**DEFENSE NUCLEAR FACILITIES
SAFETY BOARD**

Staff Issue Report

SUBJECT: Review of the System Back Out Plan and Ventilation System for the Plutonium Finishing Plant Project

Figure 1. PFP HEPA Filter Design

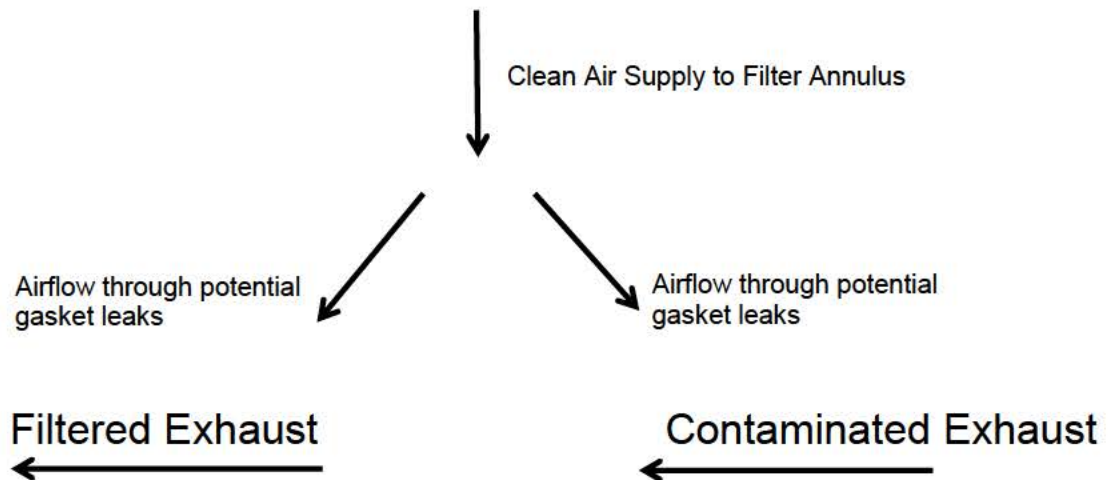
The PFP HEPA filter plenum includes a unique capability to mitigate the effects of potential leakage around the HEPA gaskets that seal the filter to the plenum (see Figure 1). The design includes a gasket on the up and downstream faces of each filter, creating an annular space around the filter case. For ~45 years, a separate air supply system provided the annular space with clean, pressurized air to ensure that any gasket leaks resulted in the flow of clean air into the filter plenum rather than the flow of contaminated exhaust air around the filter gaskets. In the mid-1990s, PFP personnel terminated operation of the system's supply fan due to high vibration. The supply system continued to operate passively, relying on the negative pressure in the filter plenum to pull clean air from the supply system through any gasket leaks. Over time, the HEPA gasket seals deteriorated and flow through the supply system increased. Recent repairs and changes in damper position have reduced the flow through the system to a negligible level.

The PFP TSR requires an annual aerosol leak test of the HEPA filters to ensure that leakage around or through the filters remains within the limits prescribed by the safety basis. The review team questioned the adequacy of the leak test to detect leakage around the filters given their unique design. Specifically, because the supply system communicating with the annular space around the filters provides clean air to any leak sites, the aerosol leak test would not be capable of detecting a potential leak path around the filters (i.e., the influx of clean air

would preclude test aerosol from leaking past the gaskets). The only indication available to detect HEPA gasket degradation, and thus the potential for bypass leakage, is a differential pressure gauge on the supply system that provides a crude estimate of the airflow leaking through the gaskets into the filter plenum. The TSR, however, does not establish requirements to monitor this flow. Consequently, the review team concluded that the TSR does not establish an adequate surveillance for confirming HEPA filter operability.

The review team expressed further concern that the system configuration could lead to an unanalyzed bypass leakage condition during accidents that result in high filter loading such as a major fire. As HEPA filters load with particulate during an accident, the ventilation control system maintains the pressure upstream of the HEPA filters constant while the pressure downstream becomes more negative. The increasing pressure drop across the HEPA filters could facilitate a bypass leakage pathway around the filters if the gaskets are not leak tight and the leakage through the downstream gasket is sufficient to draw the annular space negative with respect to the plenum upstream of the HEPA filters.

The review team acknowledges that significant dilution would be expected for any bypass leakage due to the elevated release from PFP's stack. However, the review team concluded that the bypass scenario could challenge the efficiency credited in the DSA for the safety-significant HEPA filters. CHPRC and DOE-RL personnel did not disagree with this concern. Before committing to address it, they are reviewing previous technical analyses that they believe evaluated potential bypass leakage pathways. They committed to providing the staff with the results of their investigation upon completion.
